TITLE MODIFICATION TO SKI RETRACT ASSIST UNIT BEACH 18 WHEEL-SKI		CLASS NO. 14395	ISSUE D	FILE CODE 112 -24
EFFECTIVE AS NOTED				
DWS. NO.		DISTRIBUTION— A—ACTION B—INFORMATION		
W/O NO.		TO A B		
SUBMITTERS ORDER NO.		C DESIGN D A/O E F G		
CUSTOMER		H I J K L M N O P Q		
TYPE OR MODEL BEACH 18 SKI-PLANE		A/O PLANT'S MARKS "		
SUBCRAFT REGISTRATION NO.		MATERIAL A/O CMT.		
DATE 24 FEB '65		MOUNT. SUFT. SALES/CONT.		
DRAWING NO.		INSPECTION R.O.A.P.		
REVISIONS		TEST FLIGHT ENG. CONTROL		
CUSTOMER		DOT		
PURCHASER

MODIFICATION TO SKI RETRACT ASSIST UNIT
BEECH 18 WHEEL-SKI

14395

FIG. 1.

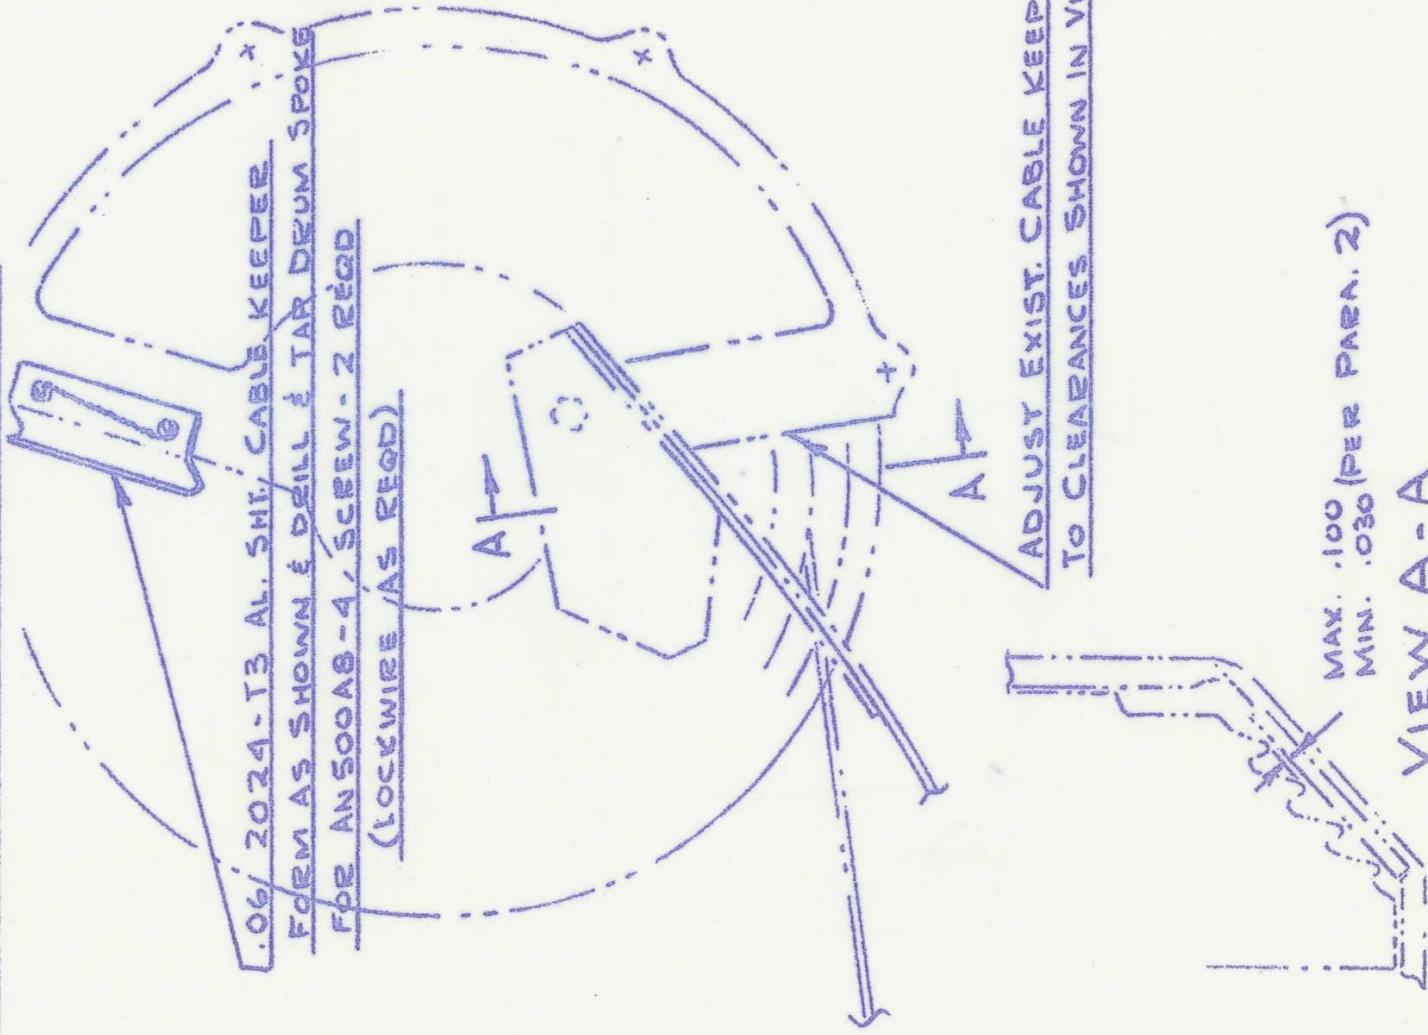
3. Install an additional cable keeper as shown in Fig. 1. This additional keeper must be adjusted to the same tolerances as in Para 2.
4. Install the retaining screw for the cable tensioning bolt as

MAX. .100 (PER PARA. 2)
MIN. .030
